February 14, 1992  
LD-92-020

Docket No. 52-002

Subject: Response to NRC Requests for Additional Information

RESPONSE TO NRC REQUESTS FOR ADDITIONAL INFORMATION  
REACTOR SYSTEMS BRANCH

Figure 5.2-1 SYSTEM 80<sup>+</sup> MASS ADDITION TRANSIENT  
(INADVERTENT SAFETY INJECTION ACTUATION)

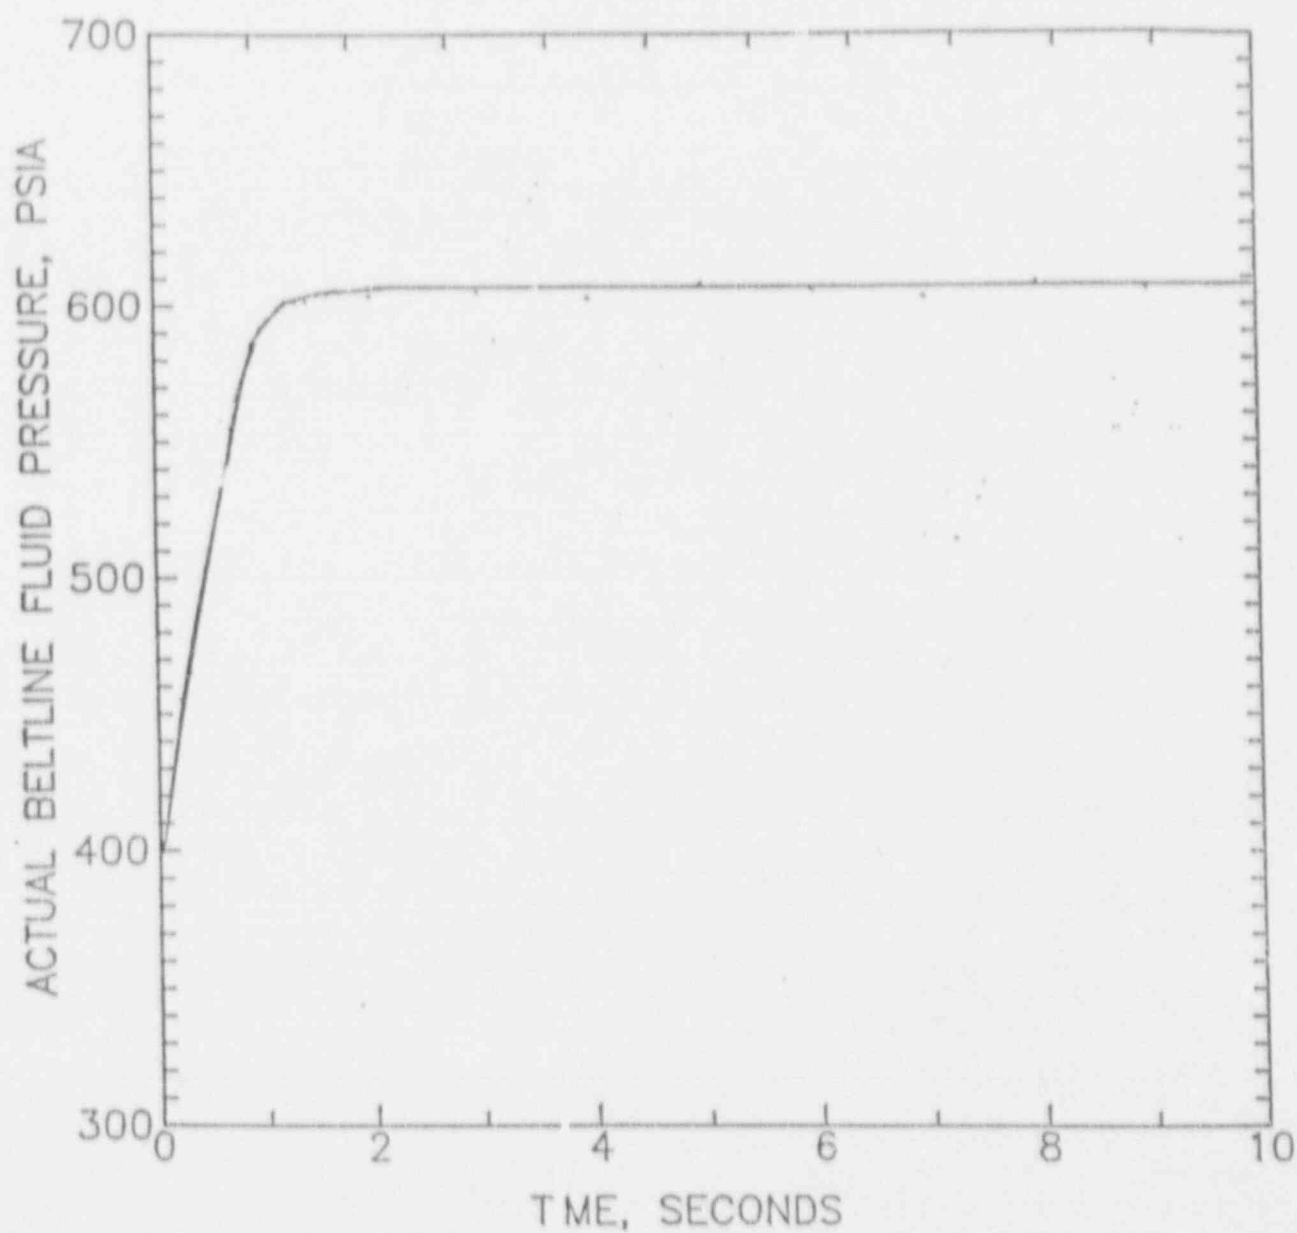
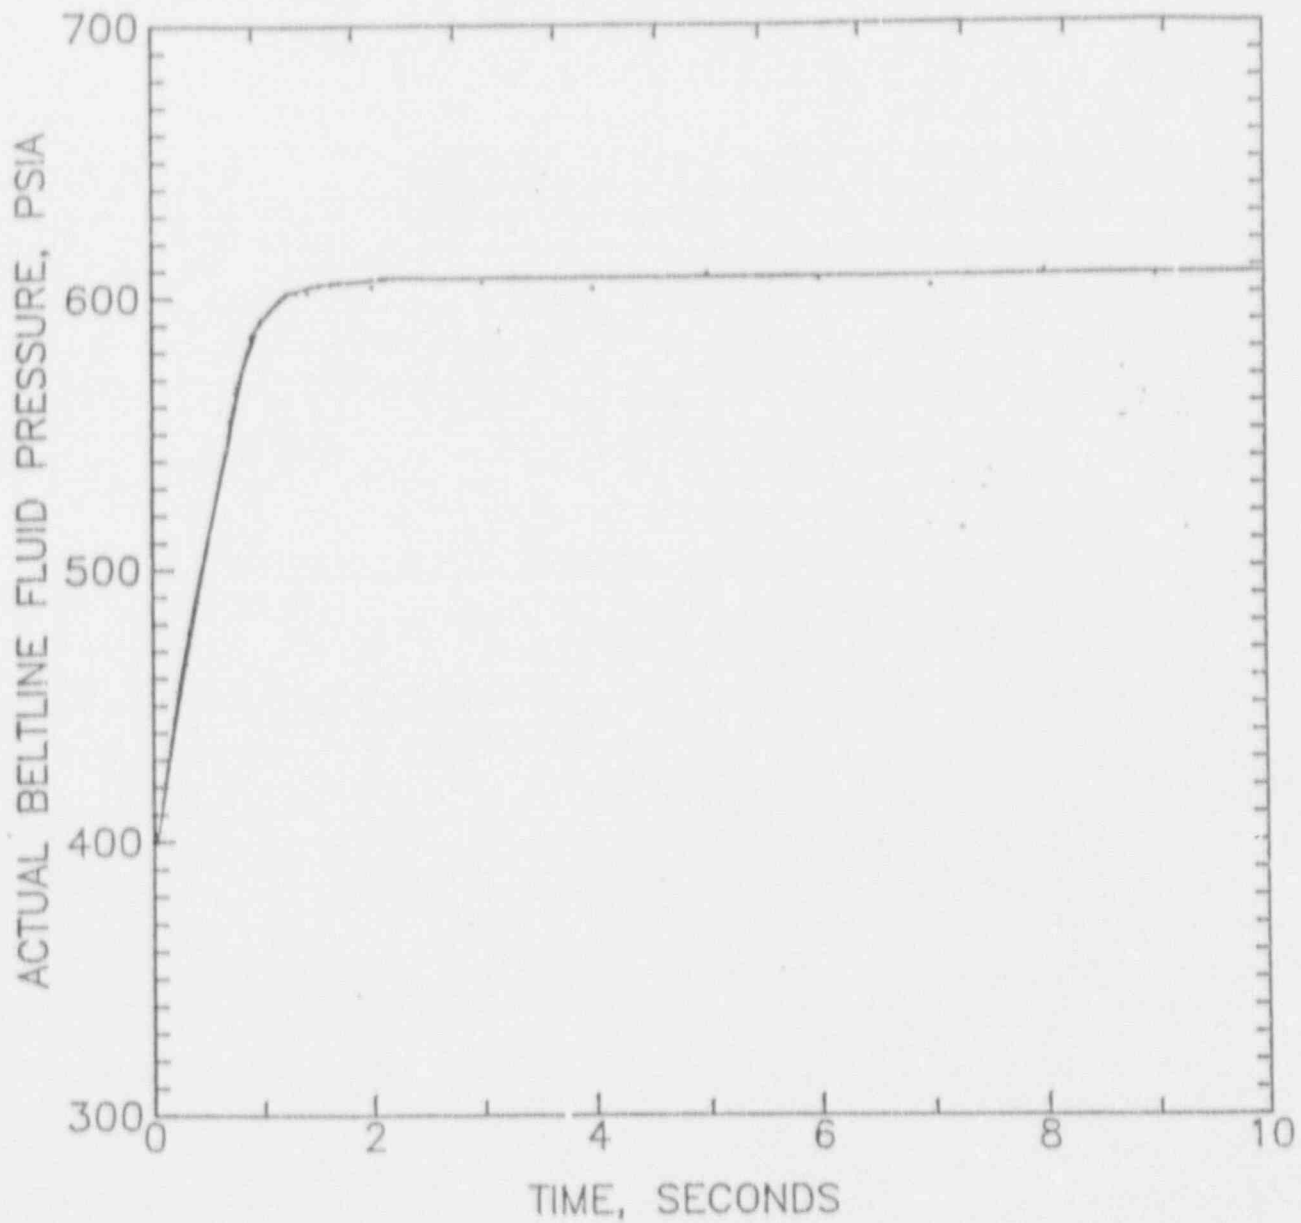
Provide the results of the analyses for the design basis mass addition and energy addition transients including transient curves that demonstrate the peak RCS pressures are within pressure temperature limits determined for the System 80+ design. Instrumentation uncertainties should be factored into your evaluation.

The results of the design basis mass addition and energy addition transients are attached and will be included in CESSAR-DC Chapter 5 section 5.2.2.10. These figures will appear in a future amendment to CESSAR-DC.

Replace with new  
Figure 5.2-1

Figure  
9.3.4-1

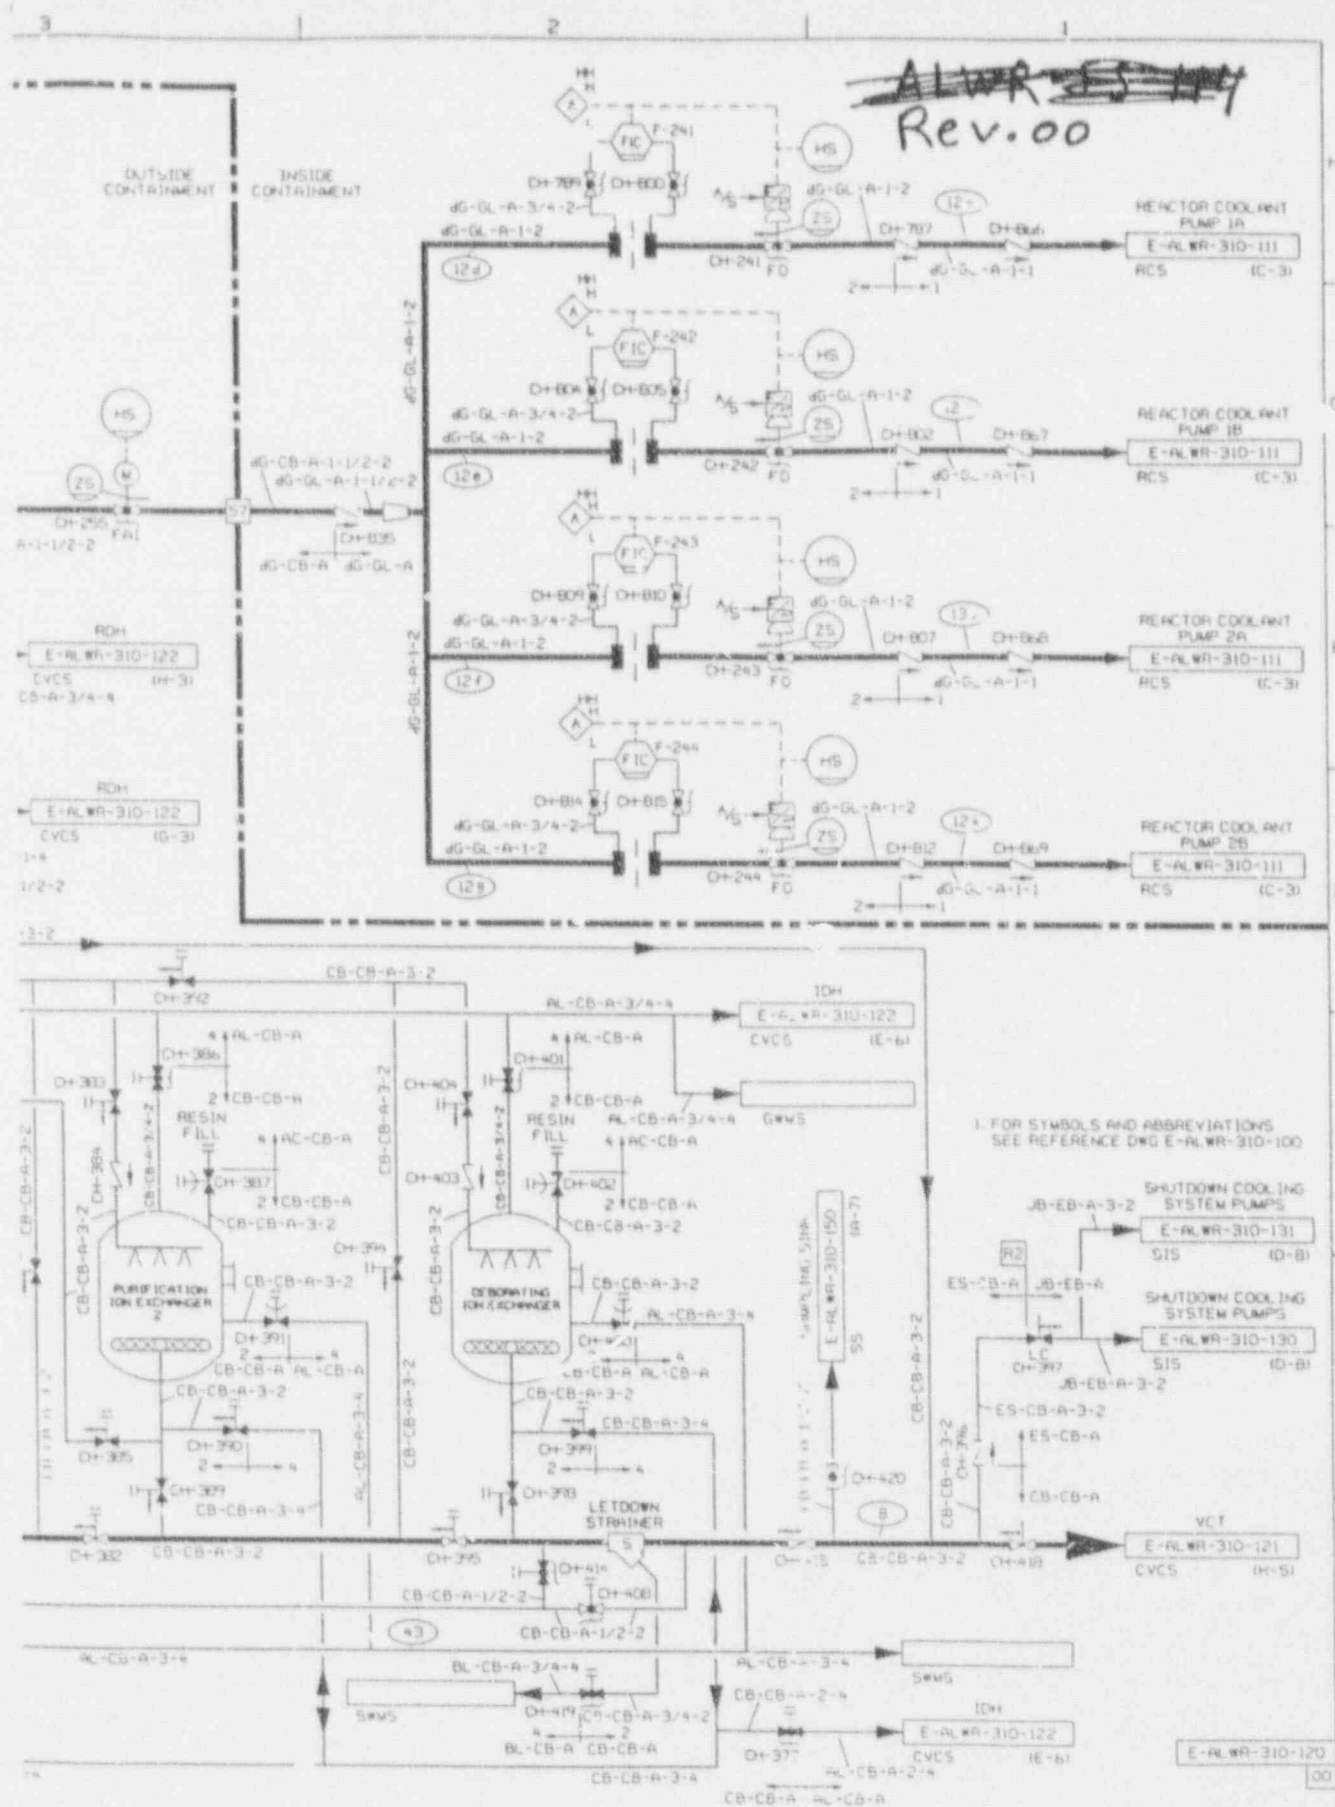
Our initial review of System 80+ design features, including proposed resolution of generic safety issue GI 105, does not provide adequate information on how these systems will satisfy the above staff position for evolutionary ALWRs. Please provide detailed discussion of how the System 80+ design meets the above criteria. As part of the response include:

This discussion refers to CESSAR-DC Figure 9.3.4-1, Sheets 1 and 2. Sheet 1 has been marked up to reflect revisions which will be incorporated into the next Amendment to CESSAR-DC. This sheet is attached for information. Sheet 2 can be found in CESSAR-DC. The P&ID coordinates for the valves listed below are provided in Table 440.45-1 of this response.

The letdown orifices (Sheet 1 of Figure 9.3.4-1, coordinates F-7) limit letdown flow to its maximum allowable value if the letdown control valves are fully open. The orifices are located in containment, upstream of the outer containment isolation valve (CH-523) in piping designed to RCS design pressure. The letdown line relief valve (CH-354) is located downstream of the letdown control valve isolation valves. CH-354 has a capacity equal to the capacity of the letdown orifices with the letdown control valve fully open. Overpressurization protection is thus provided for portions of the letdown flowpath designed to a pressure less than design pressure.

Auxiliary Spray Line -- The auxiliary spray line (at coordinates H-7 and H-6 on Sheet 1 of Figure 9.3.4-1) is a path parallel to the charging line. It has the same piping design pressure rating and the same design configuration as the charging line. Five check valves in series separate the charging pump suction piping from RCS pressure. As stated above, it is implausible that the charging pump suction piping could be overpressurized by the RCS.

FIGURE 1

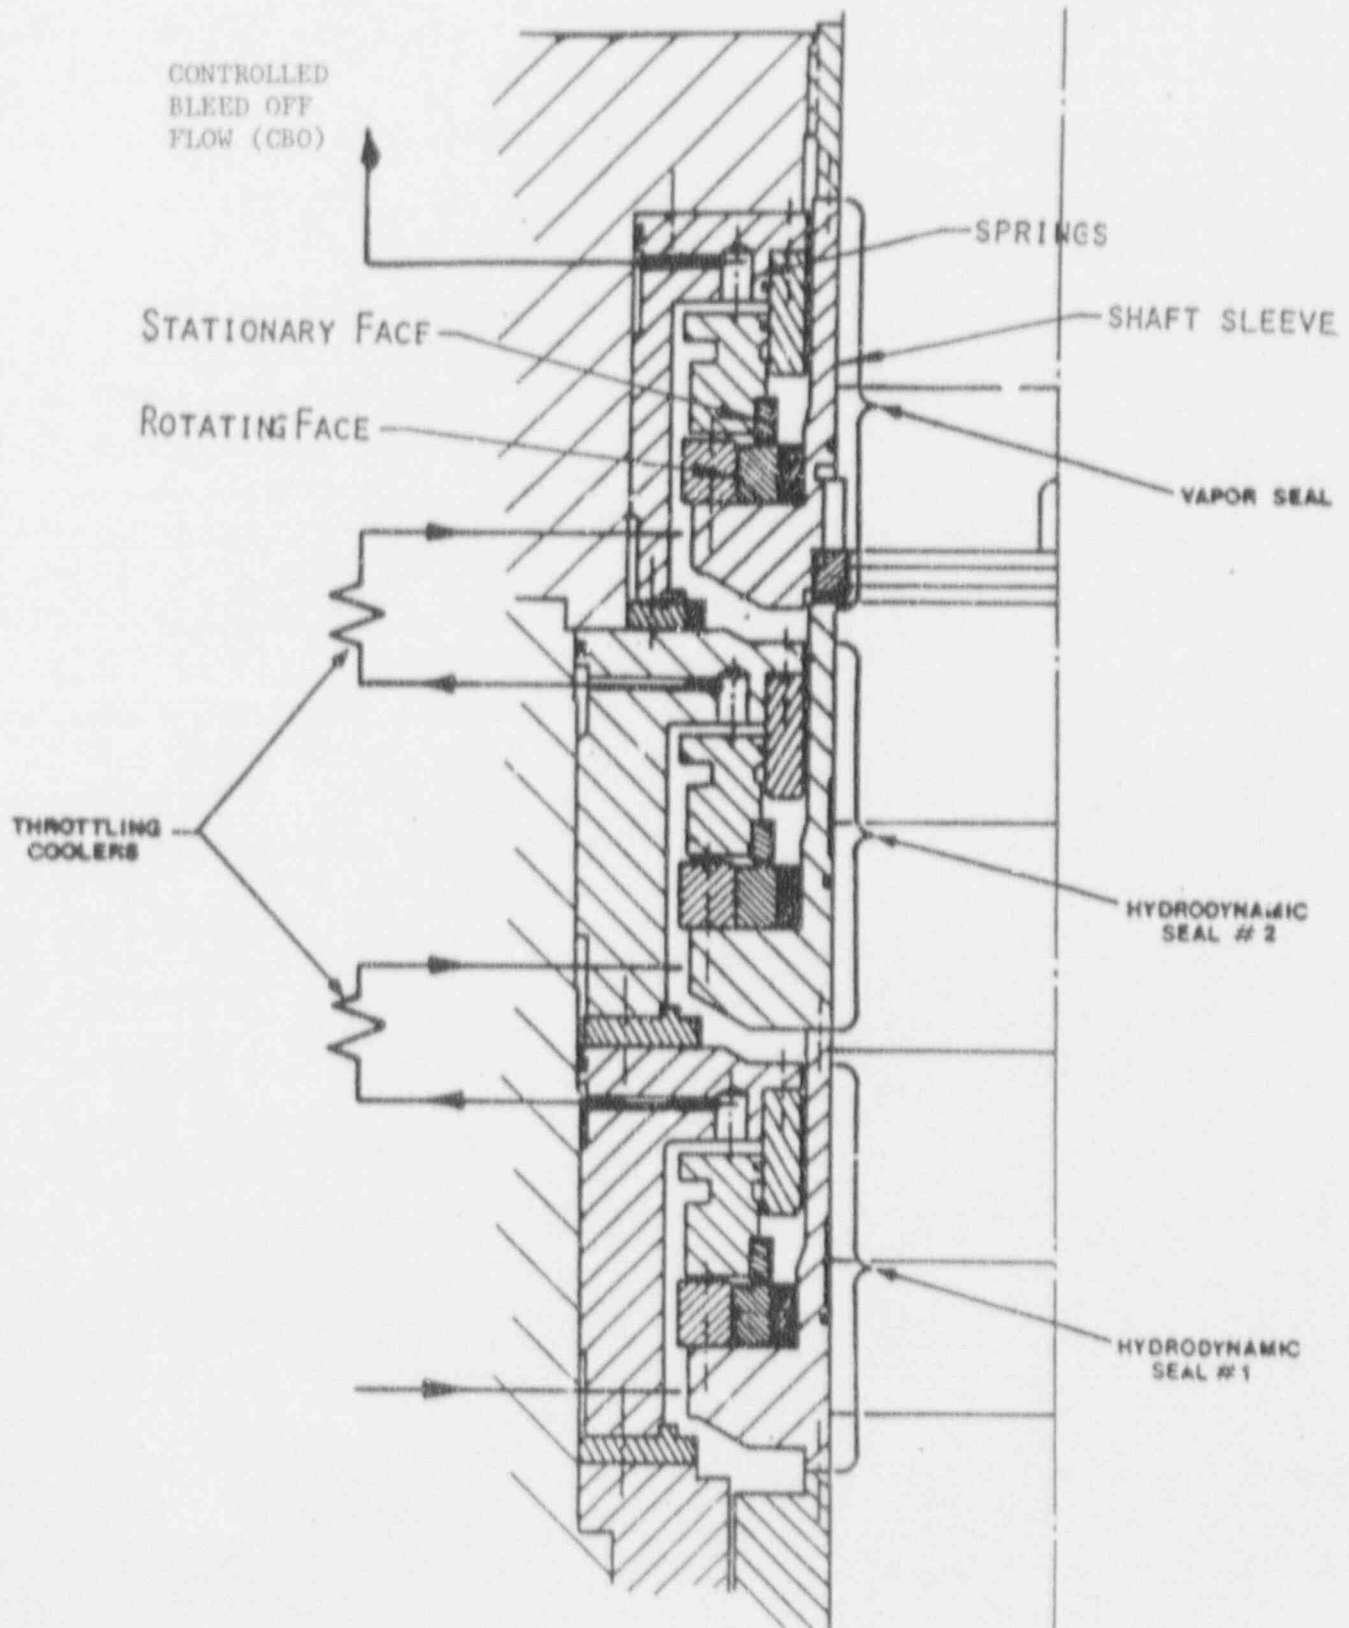
As part of the response to the above RAIs related to RCP seal integrity (GSI-23) and HPSC/TSC tube rupture analysis, provide a color coded simplified P&ID(s) of the CE-KSB RCP shaft seal system to be used in the System 80+ design clearly identifying:

The System 80+ RCP uses a system of three seals, Figure 1, to seal the main shaft. The seals are supplied with filtered, chemically controlled seal injection water by the Chemical Volume Control System (CVCS). Two hydrodynamic seals are mounted in series, with a third stage vapor seal mounted above the two lower stages. Reactor coolant system (RCS) pressure is reduced to volume control tank pressure in stages by the controlled leakage bypass system, which contains throttling devices which are also called throttle seal coolers (TSC). The first two seals provide approximately 84 percent of the system pressure drop (42 percent each). The pressure drop across the third seal is approximately 16 percent. Each of the three seals is capable of operating at full system pressure.
